ADDRESS: 1617 WALNUT ST

Proposal: Replace French door, alter entranceway and install security gate, add signage

Review Requested: Final Approval

Staff Contact: Ted Maust, theodore.maust@phila.gov

Figure 1: 1921 news clipping shows the original facade of 1617 Walnut Street.

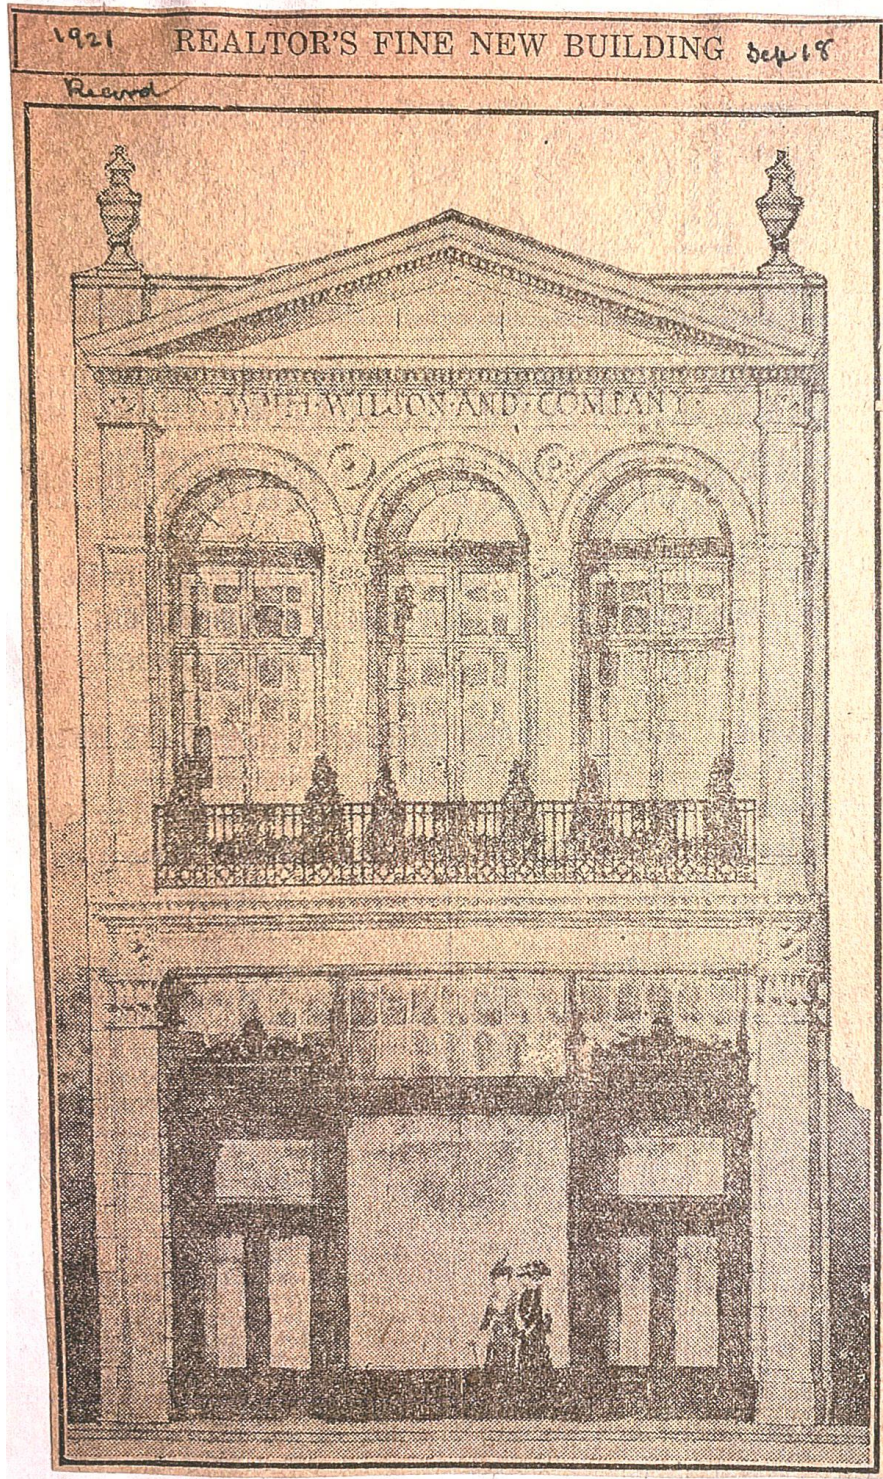
OVERVIEW: This application proposes to install signage, replace a historic second-floor French door, and make significant changes to the non-historic first-floor entryway to 1617 Walnut Street. The first floor of the building has been modified several times, most recently in a style which echoes features of the second floor.

PROPOSED EXTERIOR FRONT ELEVATION

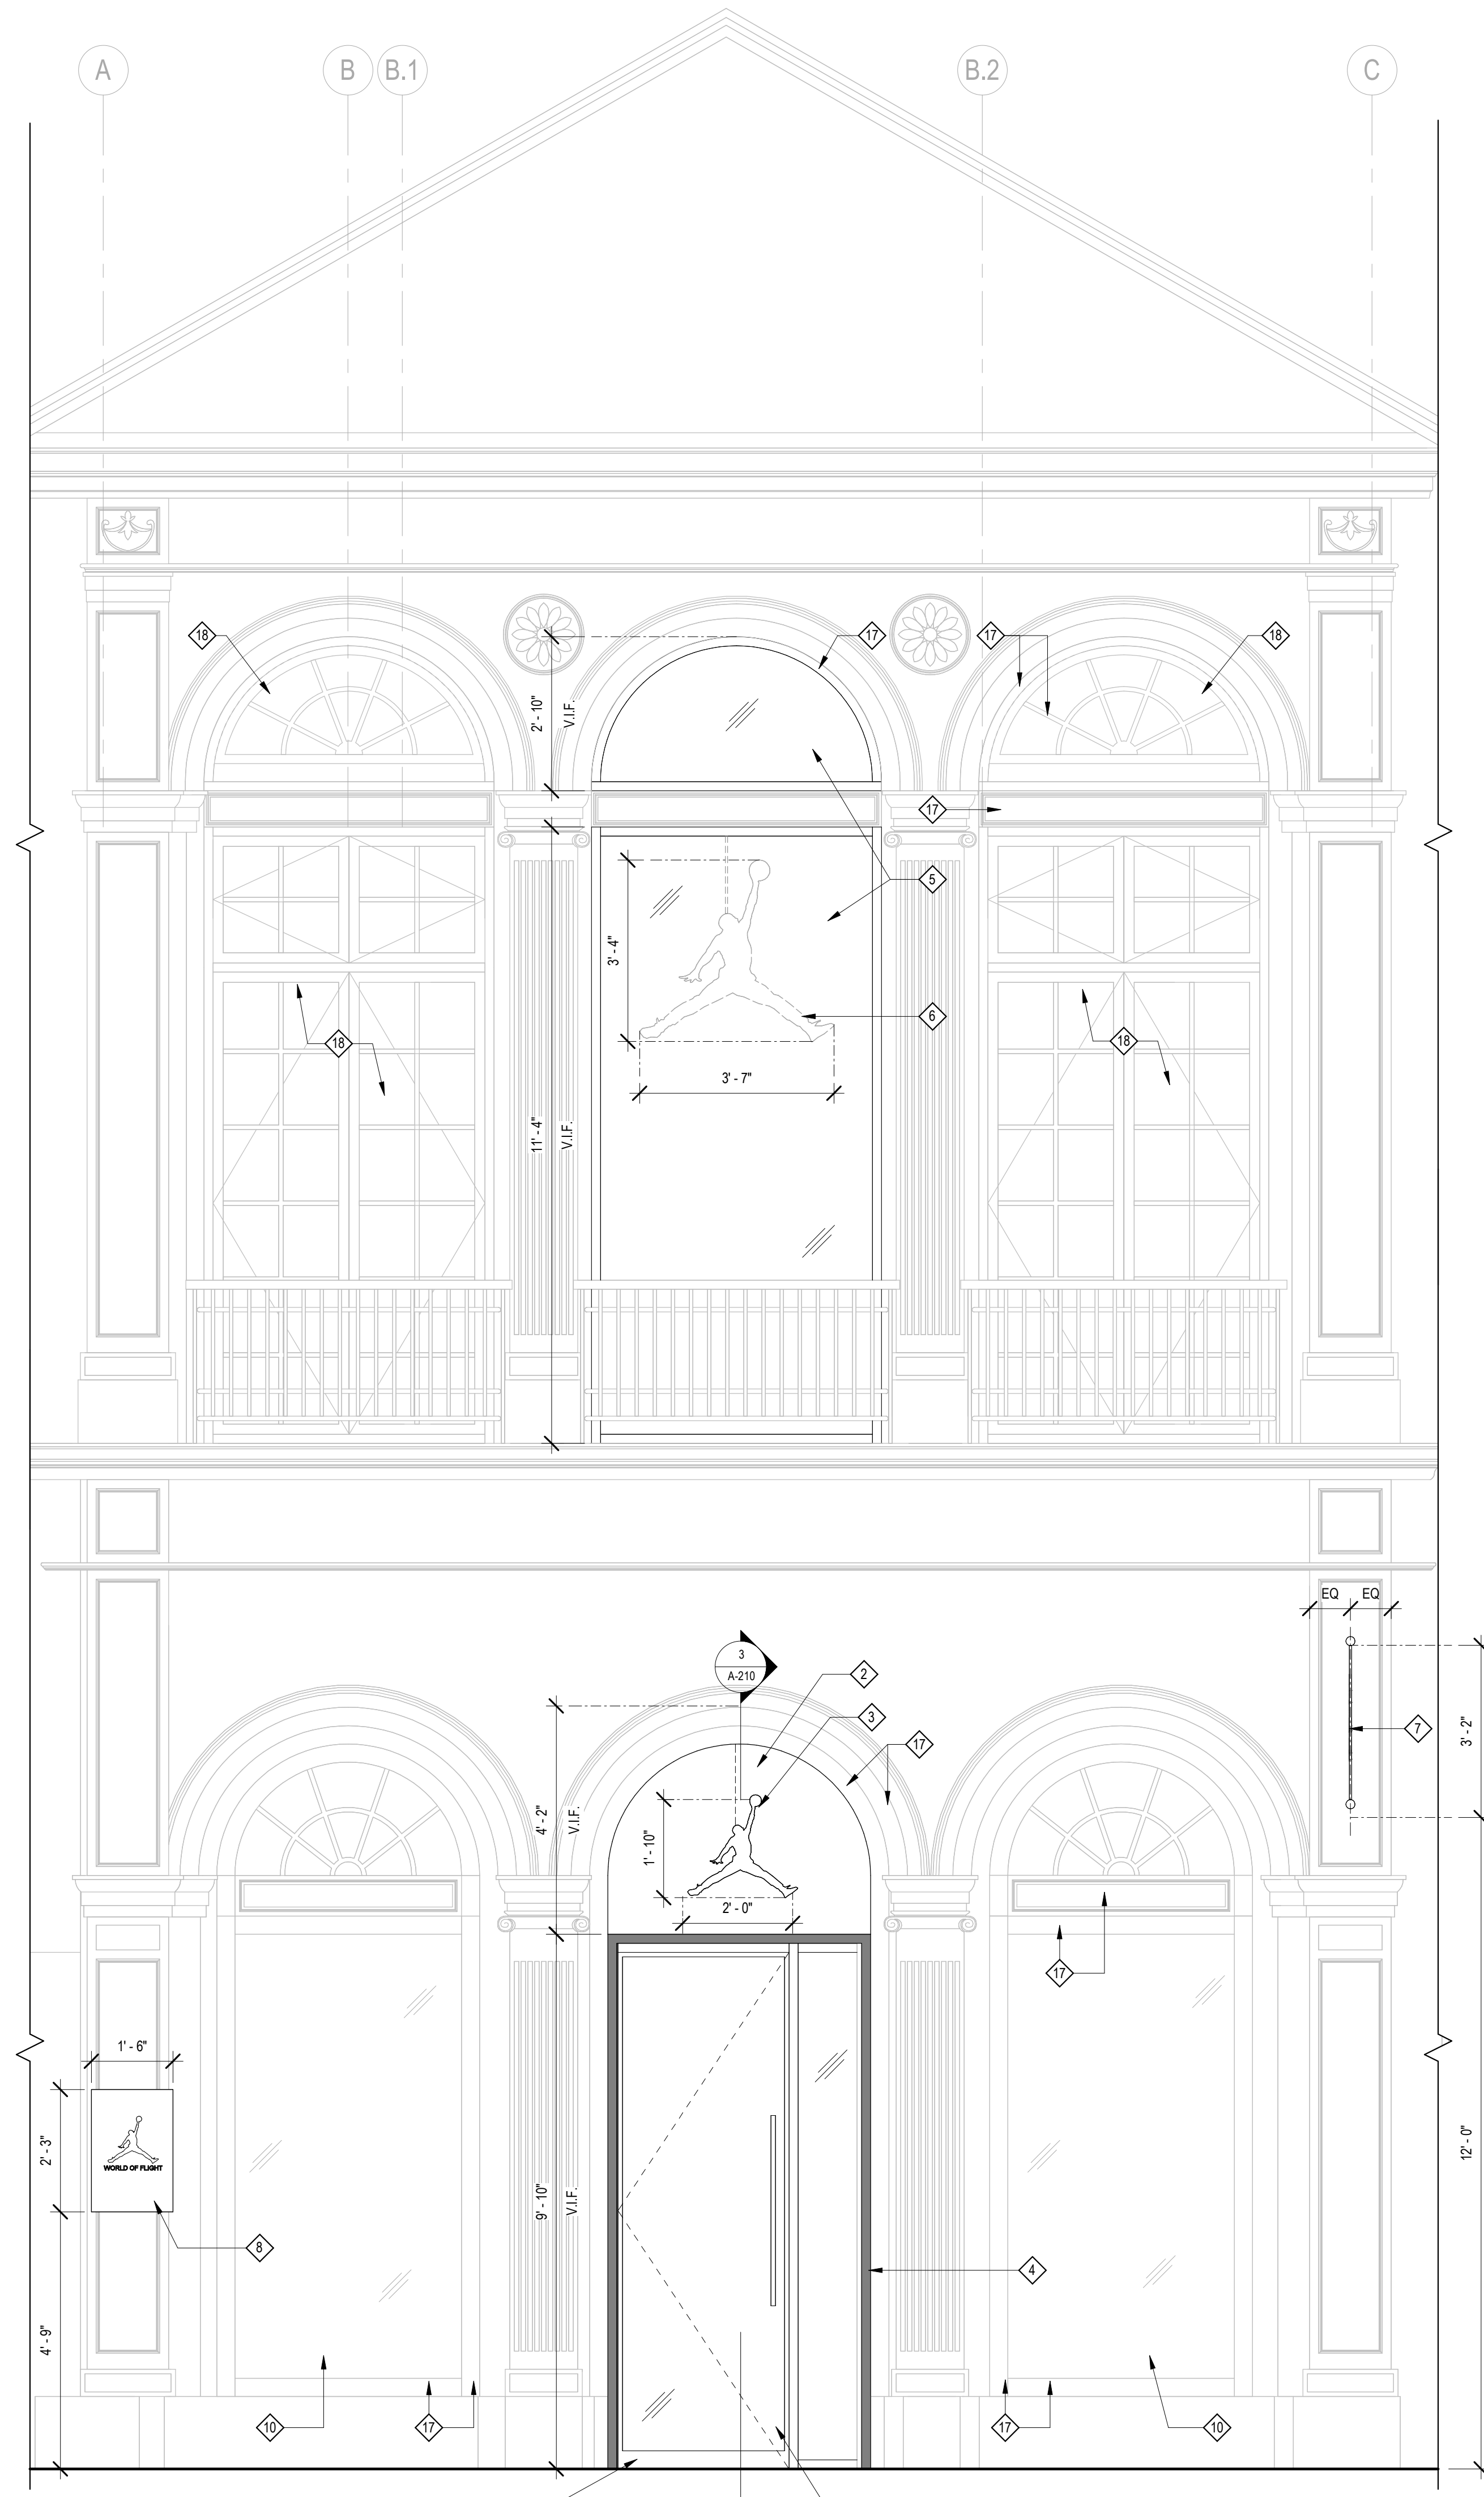
At the first floor, the application proposes to remove the existing non-historic central entry doors and install a new fully-glazed door and sidelight recessed in a new metal-clad vestibule. A metal panel with illuminated signage would be installed in front of the existing transom location. The housing for a metal roll-down gate would be installed behind the panel. The staff notes that the dimensions of the panel appear differently in section and elevation.

In the central bay of the second floor, the application proposes to replace the historic divided-light French door with plate glass windows. Only the historic transom bar would remain.

- *Standard 2: The historic character of a property shall be retained and preserved. The removal of historic materials or alteration of features and spaces that characterize a property shall be avoided.*
 - The existing first-floor storefront windows and doors are not original to the building. The proposed system at the first floor does not remove historic materials that characterize the property.
 - The application proposes to remove the character-defining divided-light French door in one of three openings at the second floor. This portion of the application fails to satisfy Standard 2.

STAFF RECOMMENDATION: Approval of the alterations at the first floor but denial of the alterations at the second floor, pursuant to Standard 2.
